HISTORIC AND DESIGN REVIEW COMMISSION

HDRC CASE NO: 2022-505
ADDRESS: 515 CLUB DR
LEGAL DESCRIPTION: NCB 7070 (R MATAMOROS SUB), BLOCK 9 LOT 25
ZONING: RM-4, H
CITY COUNCIL DIST.: 7
DISTRICT: Monticello Park Historic District
APPLICANT: Gilbert Garza/Garza Design-Build LLC
OWNER: Celeste Leija
TYPE OF WORK: New construction of a 1-story, single-family residence
APPLICATION RECEIVED: September 16, 2022
60-DAY REVIEW: Not applicable due to City Council Emergency Orders
CASE MANAGER: Rachel Rettaliata

The applicant is requesting conceptual approval to construct an approximately 2,400-square-foot 1-story, single-family residential structure.

PROPOSED: **REVISED** FLOOR PLAN (FLOOR PLAN FURRED)

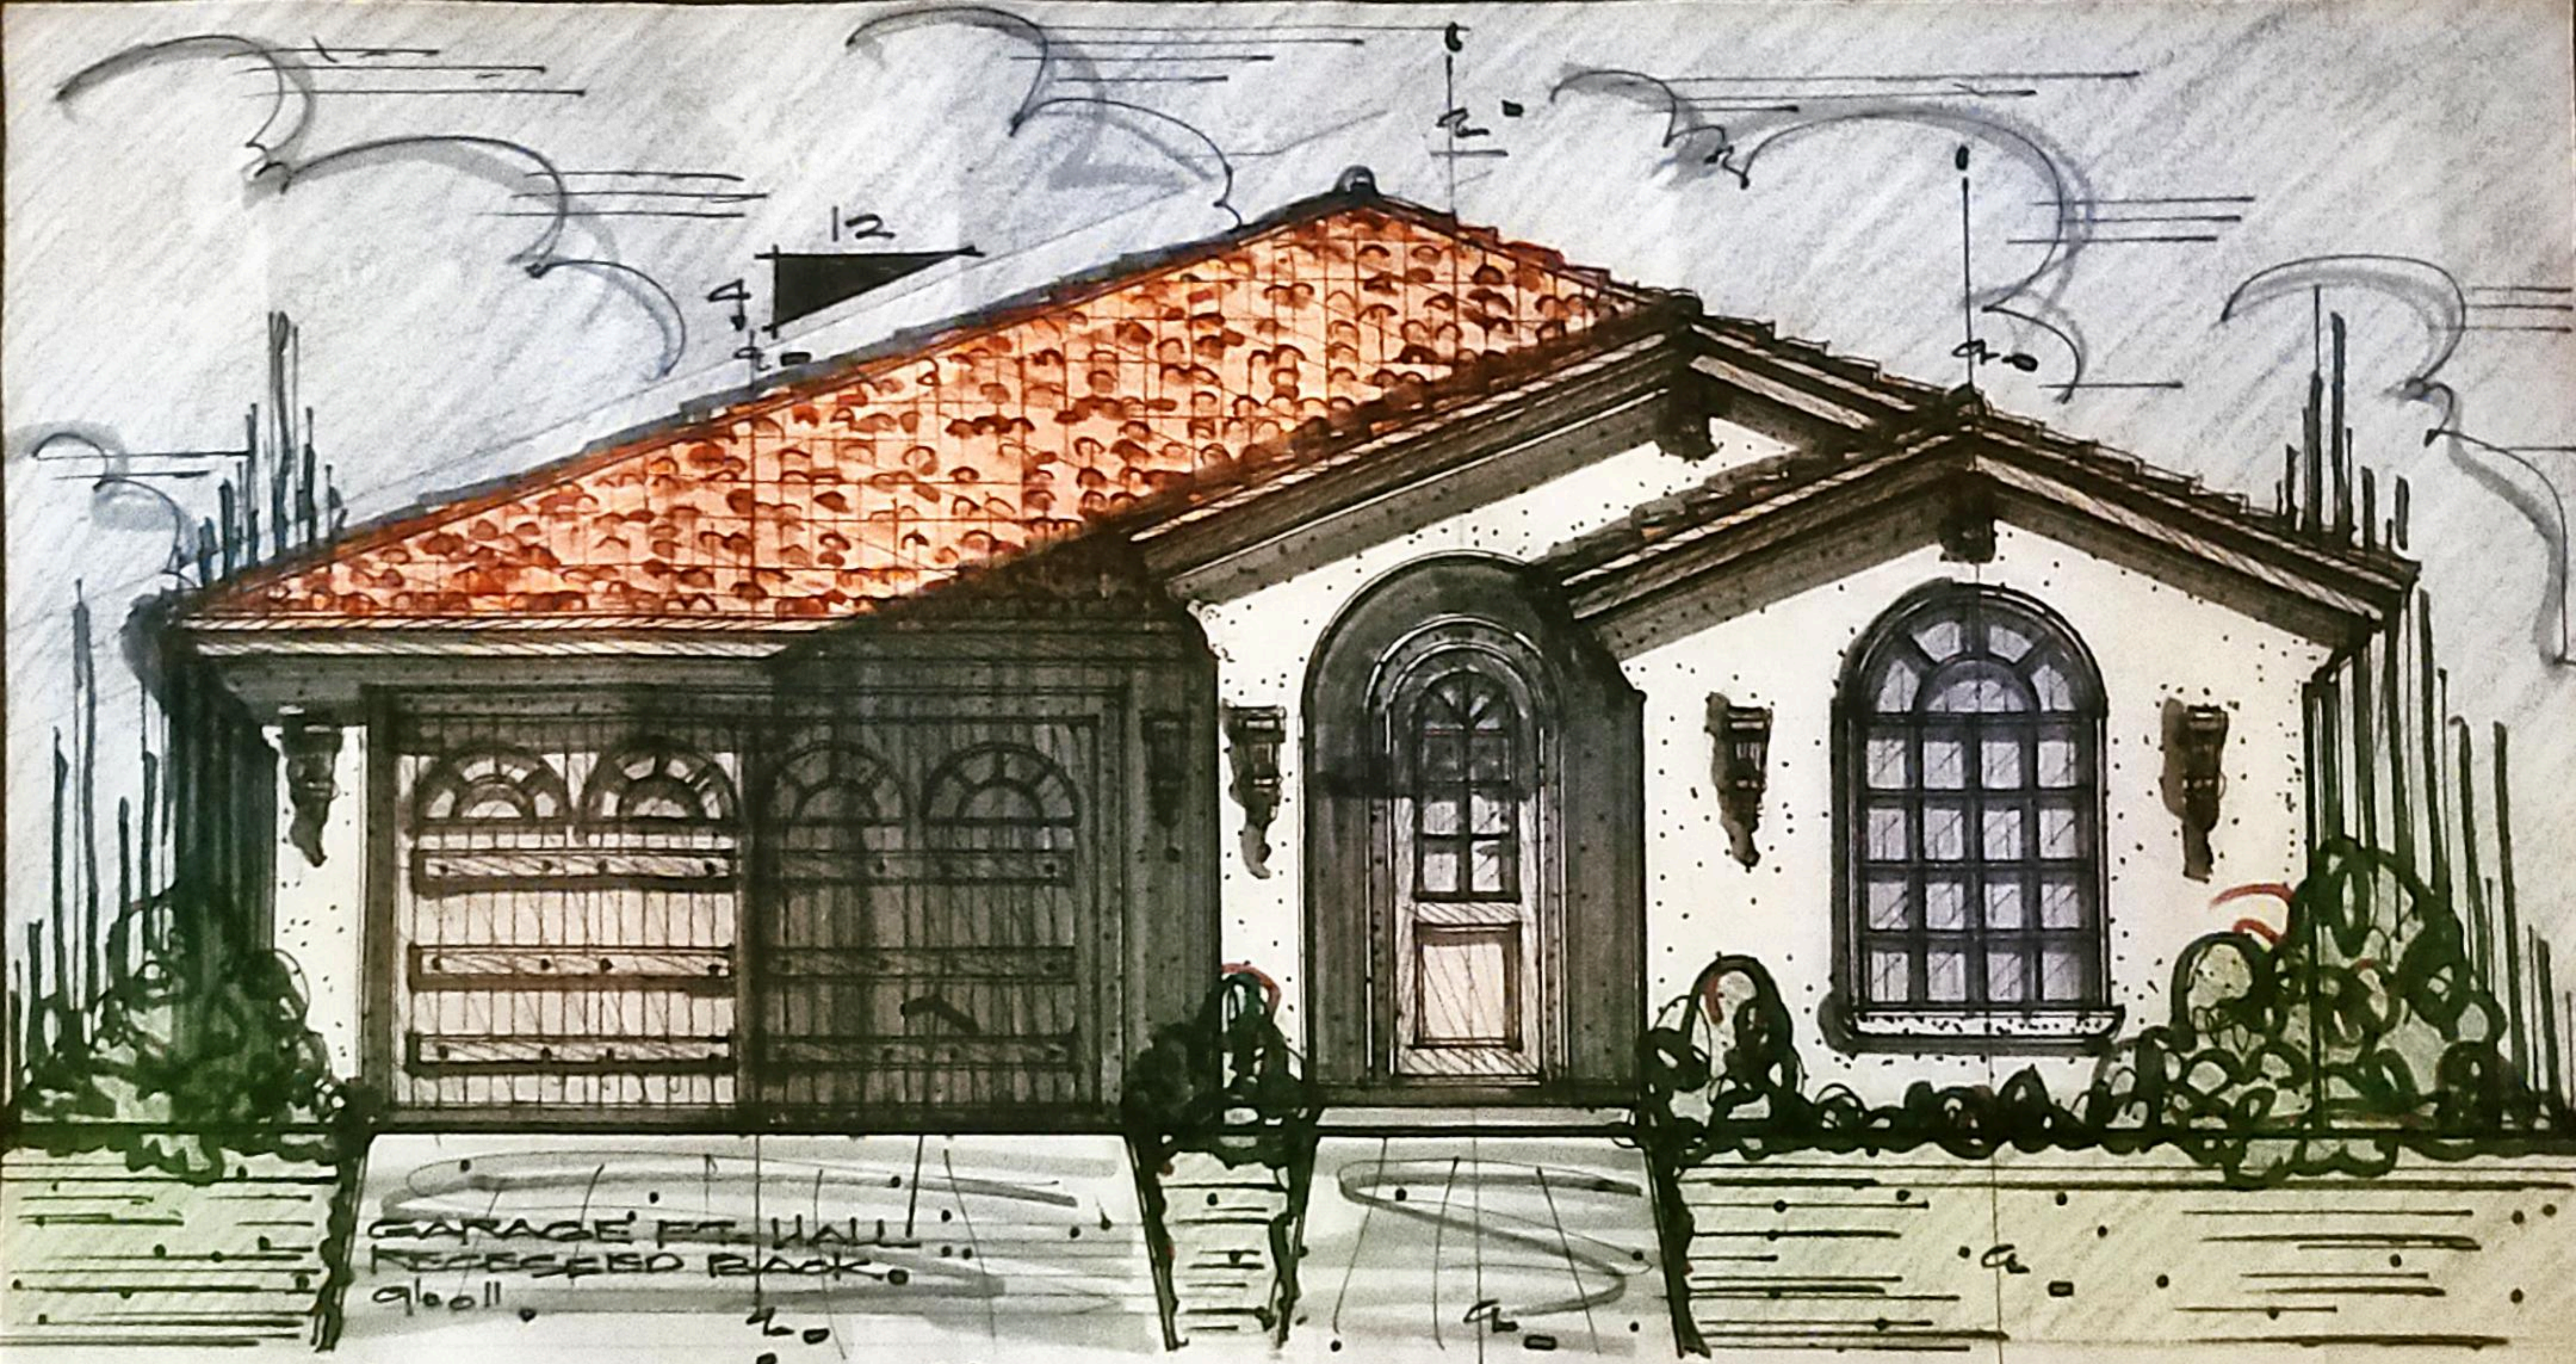
- d. SETBACK & ORIENTATION – According to the Guidelines for New Construction, the front facades of new buildings should align with the front facades of adjacent buildings where a consistent setback has been established along the street frontage. Additionally, the orientation of new construction should be consistent with the historic examples found on the block. The applicant has proposed to construct a 1-story, single family residence oriented south toward Club Drive. The existing properties along Club are oriented toward Club. The applicant has proposed a front facade setback of 30'. The front-facing garage features a 9-foot setback from the front facade. The applicant has expressed that the adjacent properties feature 30' setbacks. Staff finds that the applicant should provide an updated setback diagram showing the updated site plan in relation to the neighboring structures to staff to review.

- i. That the applicant provides an updated setback diagram showing the proposed setback in relation to the neighboring structures and the setback for the front-facing garage to staff for review prior to returning to the HDRC for final approval based on finding d.

* ORIGINAL FLOOR PLAN TO REMAIN AS-IS FOR THIS EXCEPTION
OF PLAN FURRED AND GARAGE FRONT HALL RECESSED BACK 9'0"!!

PROPOSED
WINDOW SIZE
REDUCED FROM
6'0" W. TO 5'0" W.

* FRONT FACE OF
GARAGE IS
RECESSED 9'0" =
FROM FRONT
BEDROOM FACE.

FRONT PORCH FLAT
PARAPET ROOF DELETED
AND REPLACED W/
GABLE ROOF.

1. : Floor Plan is "FLIPPED" to allow 02-Car Garage to be recessed back 9'-0" from 30'-0" Front Building Setback and from front elevation wall.
2. : Overhead Garage Door Proposed is the minimum width of 16'-0" wide.
3. : Proposed Floor Plan footprint will generally remain as is.
 - Refer, to Attached Proposed Floor Plan Drawing for additional Information.

A PROPOSED: REVISED FRONT ELEVATION.
REFER. TO ATTACHED NOTES FOR REVISED DESCRIPTION.
MR. AND MRS. LEITA SIS. CLUB DR. MONTICELLO PK.

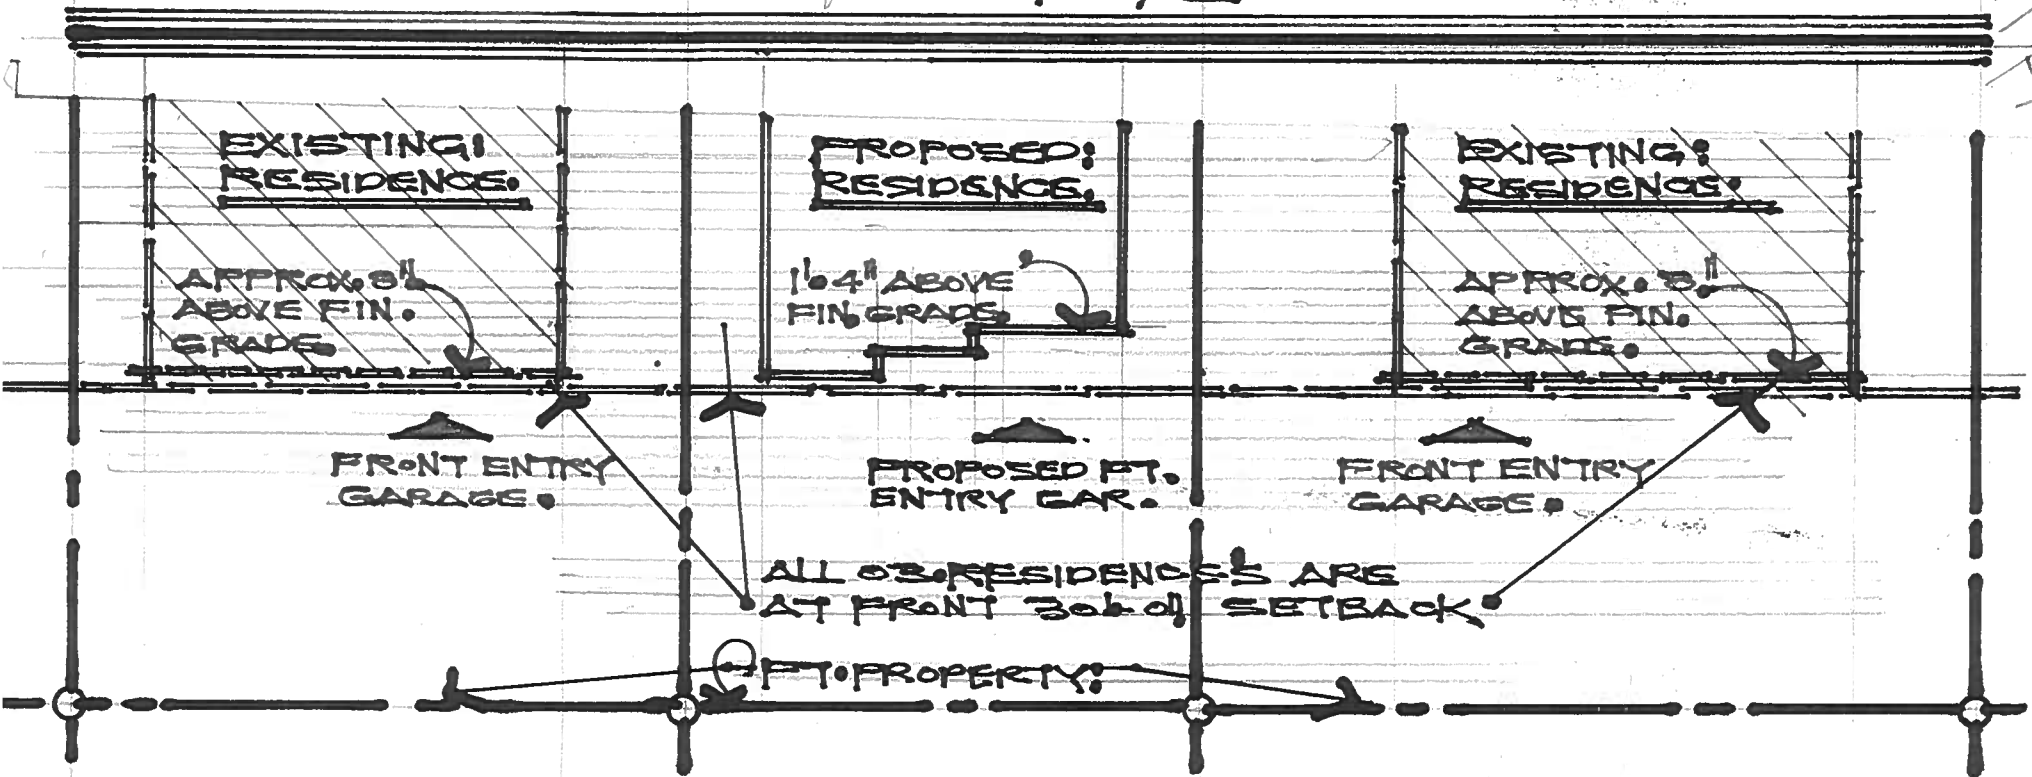
- vii. That the applicant updates the proposed fenestration to feature traditional proportions and window configurations commonly found in the district and submits updated elevation drawings to staff for review prior to returning to the HDRC based on finding j. ***This stipulation has NOT been met.***

- iv. That the applicant updates the proposed fenestration to feature traditional proportions and window configurations commonly found in the district and submits updated elevation drawings to staff for review prior to returning to the HDRC based on finding j.

AMG: The stipulation is mainly discussing the type/shape of windows being proposed. If you look at Mediterranean homes in the district it is a mix of square windows with divided lites. I think that's one of the things we are looking for is the specifications of the windows. On the left elevation, you have 2-over-2 windows that do not look uniform in size. Smaller squares and longer windows with many divided lites would be more consistent. I have a question about the right elevation, which is the garage. Now that the garage is on the other side, how is that related to the neighbor's house? We would like to not see blank walls. Door lites are also not really seen in the neighborhood.

MS: I would encourage you to look at different window manufacturers and their elevation brochures for the windows that meet the egress requirements. There are many other options, that way we have flexibility in the style. Mulled windows vs. Manufactured windows – in this neighborhood nearly all ganged windows are mulled.

1. : Front Elevation is "FLIPPED" as per Floor Plan. (Front Garage Wall Recessed 9'-0" back.)
2. : Roof Pitch is Lowered from 8 / 12 pitch to 4 / 12 Pitch.
3. : Front Entry Porch Flat Parapet Roof is Deleted and replaced with Gable Roof.
4. : Front Bedroom #02 Window is reduced from 6'-0" wide to 5'-0" wide.
5. : 02 - Side decorative wing wall are deleted.
6. : All, Stucco banding has been deleted to minimum only.
7. : Small Shed roof over 02-Car Garage door has been deleted.
 - Refer, to Attached Proposed Front Elevation Plan Drawing for additional Information.

PROPOSED: FINISH RESIDENCE HEIGHTS / SETBACK PLAN.

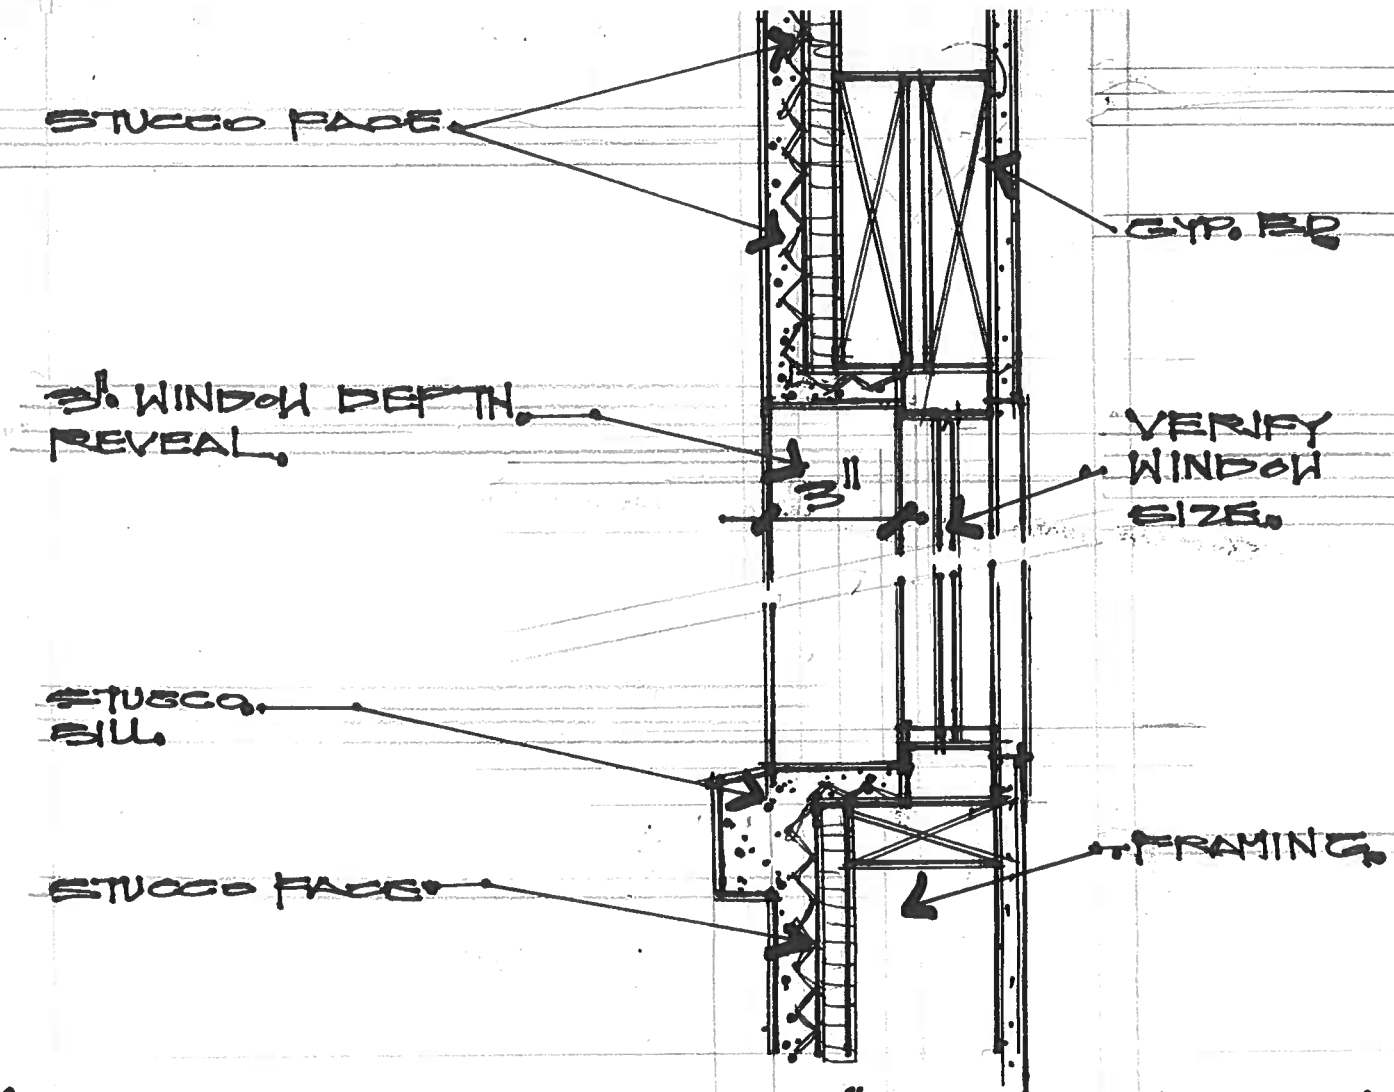
- i. That the applicant should provide a setback diagram showing the proposed setback in relation to the neighboring structures and the setback for the front-facing garage to staff for review prior to returning to the HDRC based on finding d. ***This stipulation has been met.***

MS: I'm glad to see the difference in adjacent setbacks and the finished floor heights, I'm concerned about the slope where your garage meets the slope. It would be helpful to see the context and how your house fits into the elevation.

NOTE: ALL RESIDENCES ARE WITHIN 30' 0" BLDG. FT. SETBACK AND
ALL HAVE FRONT ENTRY GARAGES

✱ PROPOSED • WINDOW 3" REVEAL DETAIL •
SCALE: 3" = 1' • 0"

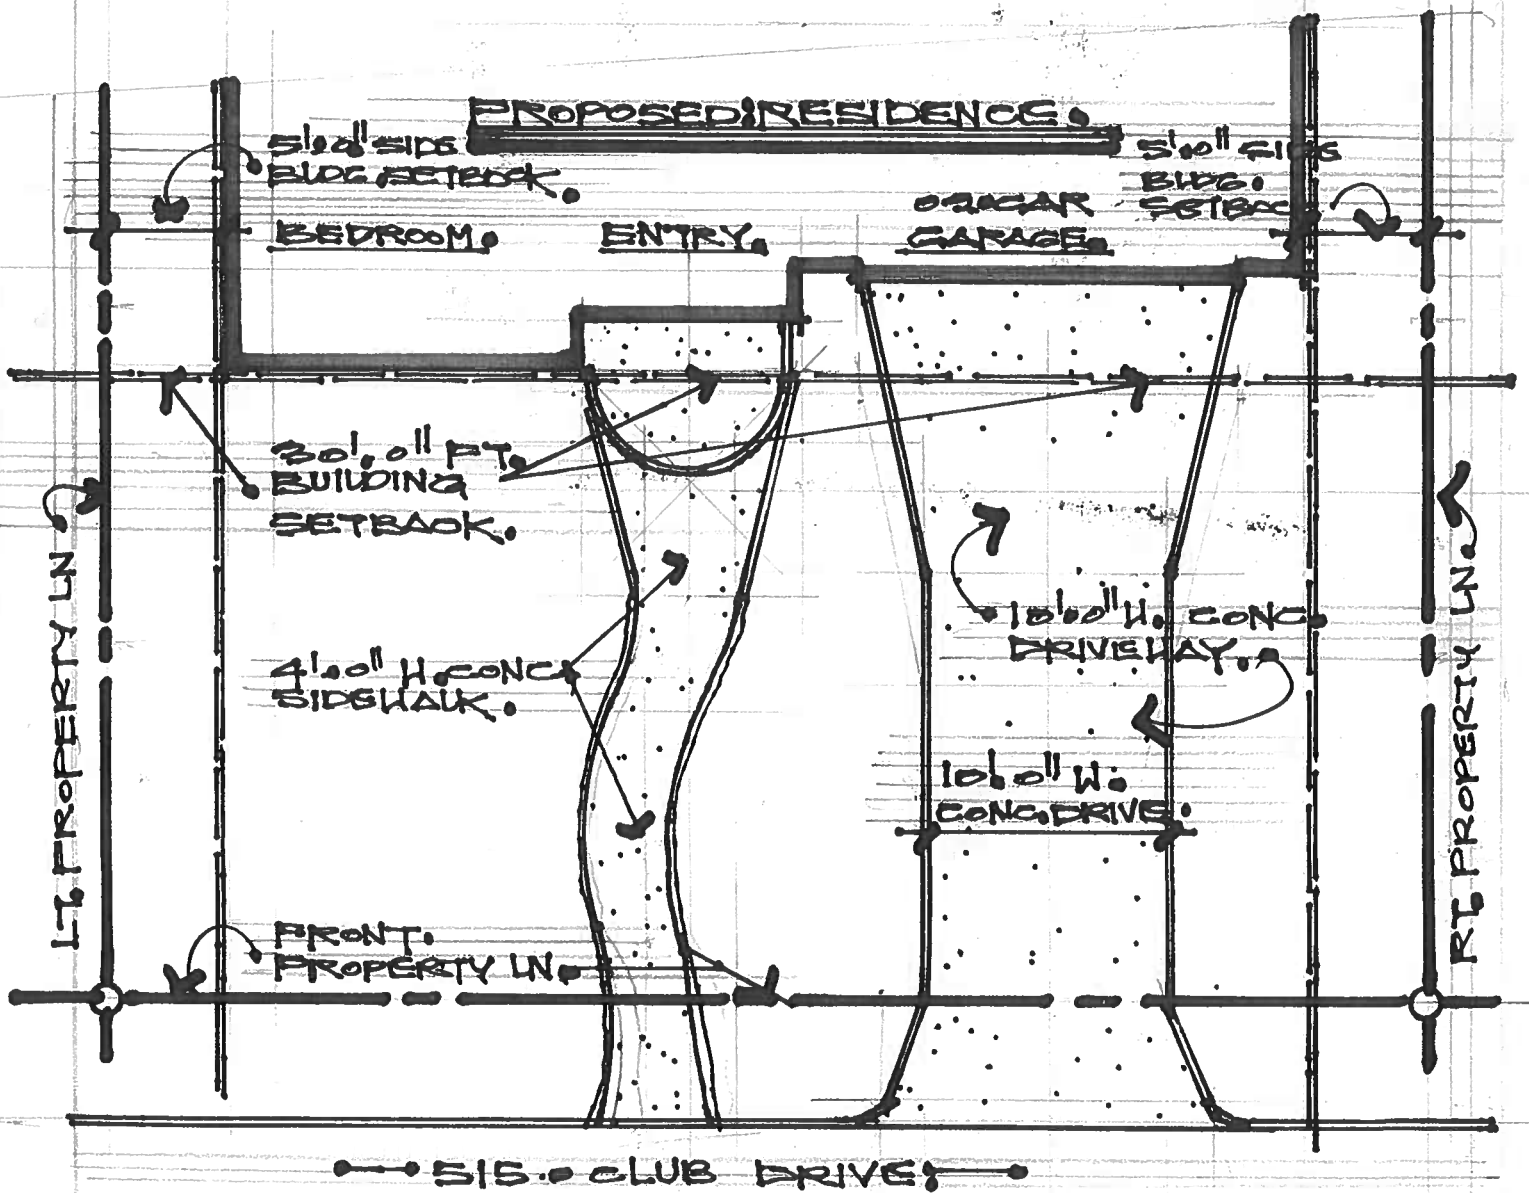
- request approval to install stucco cladding.***
- vi. That the applicant submits window specifications to staff for review prior to returning to the HDRC based on finding i. Wood or aluminum-clad wood windows are recommended. Windows should feature traditional operations, an inset of two (2) inches within facades, and profiles that are found historically within the immediate vicinity. White manufacturer's color is not allowed, and color selection must be presented to staff. There should be a minimum of two inches in depth between the front face of the window trim and the front face of the top window sash. This must be accomplished by recessing the window sufficiently within the opening or with the installation of additional window trim to add thickness. Window trim must feature traditional dimensions and architecturally appropriate sill detail. Window track components must be painted to match the window trim or concealed by a wood window screen set within the opening. ***This stipulation applies to final approval.***

- iii. That the applicant submits window specifications to staff for review prior to returning to the HDRC based on finding i. Wood or aluminum-clad wood windows are recommended. Windows should feature traditional operations, an inset of two (2) inches within facades, and profiles that are found historically within the immediate vicinity. White manufacturer's color is not allowed, and color selection must be presented to staff. There should be a minimum of two inches in depth between the front face of the window trim and the front face of the top window sash. This must be accomplished by recessing the window sufficiently within the opening or with the installation of additional window trim to add thickness. Window trim must feature traditional dimensions and architecturally appropriate sill detail. Window track components must be painted to match the window trim or concealed by a wood window screen set within the opening.

01. REFER TO ARCHITECTURAL PLANS FOR ALL WINDOW SIZES, STYLES AND LOCATIONS.
02. WINDOWS TO BE ALUM. • BLACK FRAME, DEL. INSULATED. LOW E" WINDOWS W/ SCREEN.
